Carter Street Urban Activation Precinct

Submission on behalf of Goodman Property Services (Aust)
Pty Ltd

Submitted to NSW Planning & Infrastructure

30 April 2014 ■ 14170

Figure 4 – Exhibited and Proposed Structure Plans

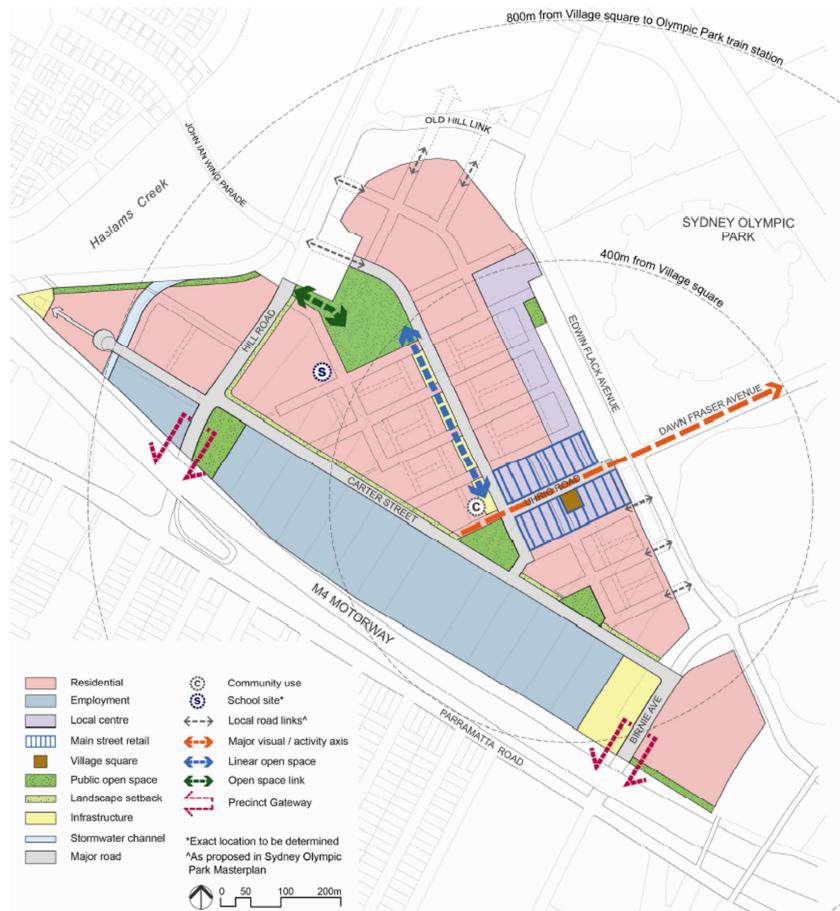
NSW P&I's and Goodman's Structure Plans are set out in **Figure 4** below to enable a direct visual comparison between the two. Goodman's Structure Plan does not incorporate the land outside of Goodman's ownership. The two Building Height Plans are also provided in **Figure 5** below for direct comparison, as there are fundamental differences in the way density is proposed to be distributed throughout the Precinct.

Differences	Justification for Change
Road network	Both schemes propose to extend John Ian Wing Parade, however in Goodman's scheme the road is aligned further to the east.	Goodman's proposed alignment of John Ian Wing Parade aligns with existing building leases. P&I's scheme fails to address the commercial realities of existing leaseholds and their sequence of expiry, which would have significant consequences for Goodman. This is addressed further below.
	P&I's scheme proposes to realign Uhrig Road whereas Goodman's scheme proposes to retain its existing alignment.	Better alignment of this intersection with Carter Street.
	Goodman's proposal includes a new north-south major road connection linking Carter Street to the John Ian Wing Parade extension and then extending further north-east from there.	This road has been proposed in order to respond to the existing topography of the land. The new road defines a significant change in landform by approximately 5m. NSW P&I's proposal proposes a series of local roads which ignore the topography and would require more land grading in terms of cut and fill which would add further expense to infrastructure costs.

P&I's proposed road network shows numerous minor north-south roads, whereas Goodman's proposal rationalises the local roads to be provide a more consolidated local road network.	P&I's proposed road network creates the following issues: <ul style="list-style-type: none"> ▪ Significant duplication of utility and stormwater drainage infrastructure (capital cost and asset maintenance burden); ▪ Significantly greater road pavement areas (capital cost and asset maintenance burden) plus the generation of large volumes of stormwater requiring treatment; ▪ More complex road network with a significant number of 4 way cross intersections which may require signal control; and ▪ Minimises block sizes which can constrain basement carpark layouts.; and ▪ Poor alignment of multiple intersections along Carter Street.
Land use distribution	Both schemes centralise the local centre precinct along Uhrig Road, however Goodman's scheme terminates the ground floor retail at the proposed north-south major road while extending it further south. Goodman's scheme also proposes to locate a new community centre adjacent to the village square.	Goodman's scheme allows for a supermarket which is not accommodated in P&I's scheme. The proposed co-location of the village square and community centre will help to encourage increased activity and community gathering in the village square.

Building height and density distribution	P&I's scheme proposes a predominant height limit of 8 storeys, with high rise buildings up to 20 storeys at certain gateway locations. Goodman's scheme proposes building heights up to 25 stories along the Uhrig Road activity spine, with one 30 storey building at the end of the Uhrig Road vista. Rather than distributing the high rise buildings as proposed by P&I, Goodman proposes to concentrate density by placing all of the high rise buildings along the Uhrig Road activity spine, and decreasing building heights as distance from the local centre increases.	There is no urban design justification for limiting building heights to 20 storeys in the Carter Street UAP. Permitting 25 storey buildings will still achieve NSW P&I's aim of the 30 storey buildings in Sydney Olympic Park to be read as the dominant built form in the skyline. Furthermore, a 30 storey building at the end of the Uhrig Road vista will establish a relationship and balance with Sydney Olympic Park and better connectedness. The concentration rather than disbursement of density is more in line with established urban design practice which places the most height and density in centres. It will also enable the intersection of Uhrig Road and John Ian Wing Parade and the village square to become a thriving urban quarter, the heart of the Carter Street UAP. The spreading of major residential towers to mark entry points to the precinct, as proposed in the exhibited Structure Plan, would have less potential to create a sense of place than Goodman's scheme. It also presents as a more economically rational development, allowing greater density in the first two stages of development to offset the significant remediation and infrastructure costs.

Open space network	P&I's Structure Plan incorporates approximately 3.1 hectares of open space, whereas Goodman's scheme incorporates approximately 3.7 hectares. Both schemes include a new Hill Road park, a bio-swale corridor linking village parks and other local neighbourhood parks. Goodman's scheme includes an additional village park in the northern part of the Precinct.	P&I's detailed secondary road pattern resulting in the intersection of nearly all roads with Carter Street will fragment the open space linkages and connections to a point where many residential blocks would feel detached from any local open space. Goodman's Structure Plan, on the other hand, creates a high level of permeability while achieving linkages and connections between nearly all areas of proposed open space. In addition the reinforcement of more formal open space linkages throughout the precinct has added significant identifiable permeability to the proposal.

Figure 7 – Exhibited and Proposed Road Networks in relation to Existing Leases
Source: Nettleton Tribe

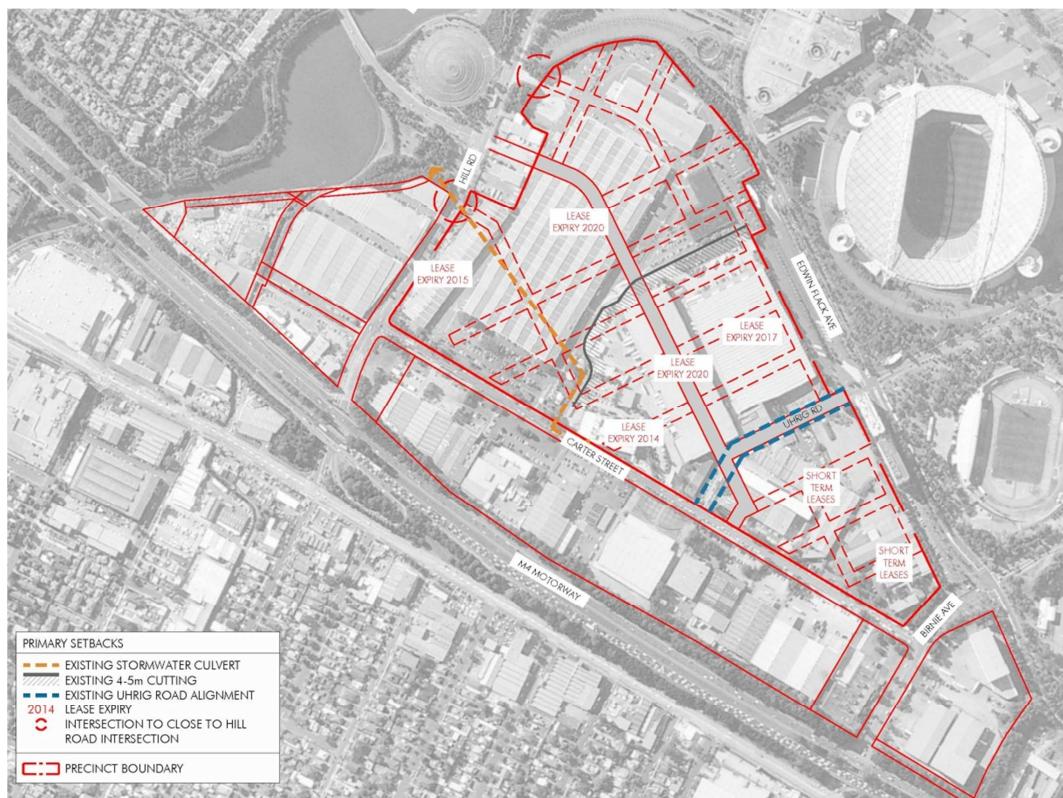
For example, NSW P&I proposes an extension of John Ian Wing Parade that will cut through 15 Carter Street which is currently leased by Rand until 2020. Goodman proposes to realign this proposed road further east so that the lease does not have to be terminated early. Instead, the road will cut through the edge of the Toll building which lease expires earlier (2017). In other words, Goodman's proposal allows the John Ian Wing Parade extension to be constructed three years earlier than NSW P&I's proposal.

The second issue with the proposed road network is that it ignores the topography of the precinct. There is a significant change in landform from approximately RL 11 to RL 5, which is defined in Goodman's proposal by a new north-south connection linking Carter Street to the John Ian Wing Parade extension and then extending further north-east from there. NSW P&I's proposal, on the other hand, proposes a series of local roads which do not respond to this topography at all. The problem with NSW P&I's proposal is that it requires far more land grading in terms of cut and fill which would add further expense to infrastructure costs. Rationalising the design and location of roads to suit the physical constraints does not diminish the outcome but is a more economically efficient use of land.

Finally, P&I's proposed road network shows numerous minor north-south roads, which should be rationalised to provide a more consolidated road network. The proposed road network creates the following issues:

- significant duplication of utility and stormwater drainage infrastructure (capital cost and asset maintenance burden);
- significantly greater road pavement areas (capital cost and asset maintenance burden) plus the generation of large volumes of stormwater requiring treatment;
- more complex road network with a significant number of 4 way cross intersections which may require signal control; and
- minimises block sizes which can constrain basement carpark layouts.

A comparison of NSW P&I's and Goodman's road network in relation to existing building leases is provided in **Figure 7**.

Figure 8 – WestConnex

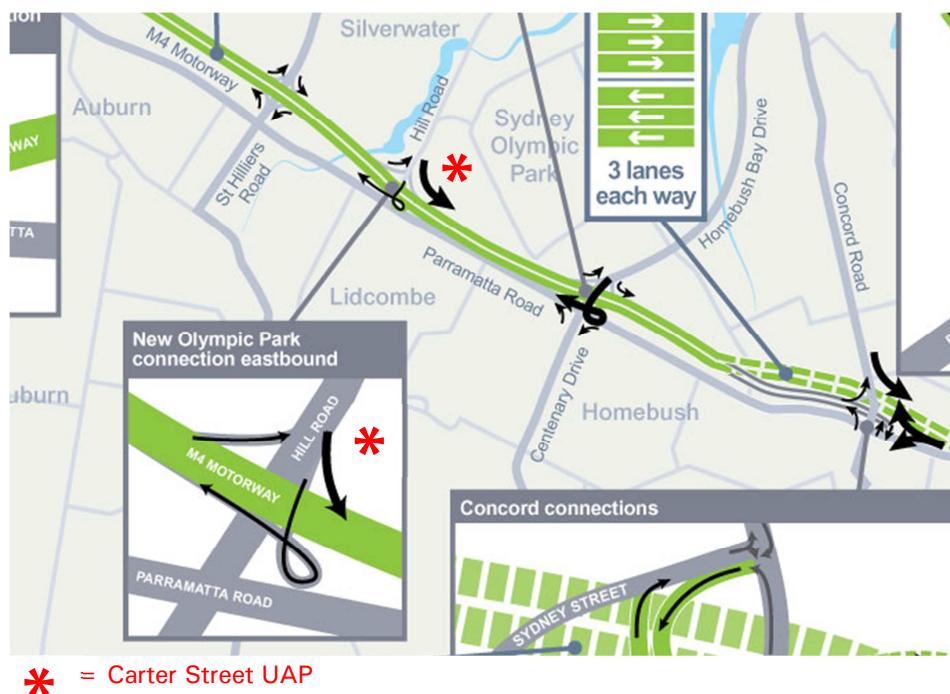
WestConnex

Due to the wider regional benefits a westbound off-ramp is likely to bring, the cost of constructing it should be borne by developers within the Carter Street UAP, Wentworth Point UAP and Sydney Olympic Park, but that cost could be offset by increased FSR.
